MEMORANDUM

Date: March 17, 2020
To: File
From: John O'Reilly, Senior Planner- Heritage
Subject: 506 & 514 Government Street- Final Inspection

506 Government Street

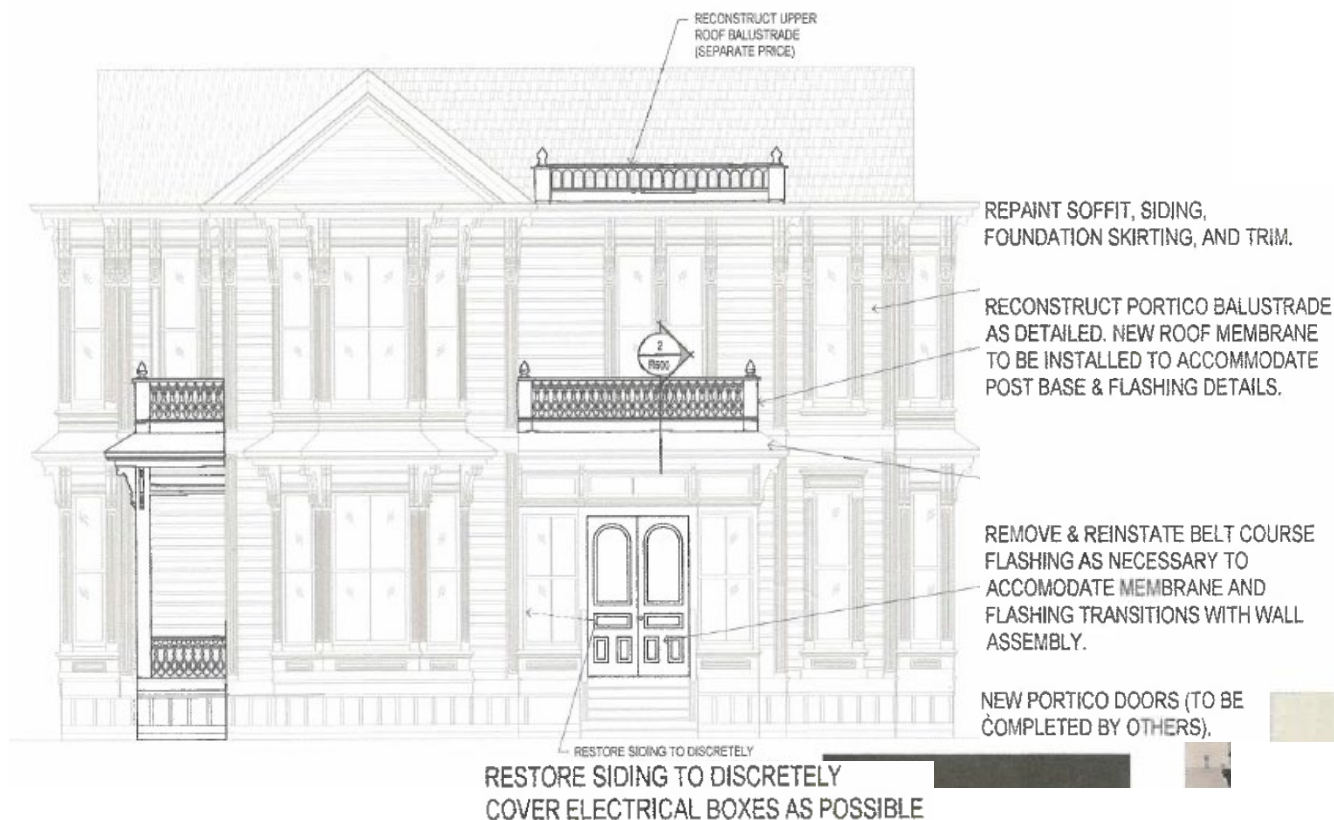
Cresting reinstalled at roof and balcony levels, lead abatement and re-painting
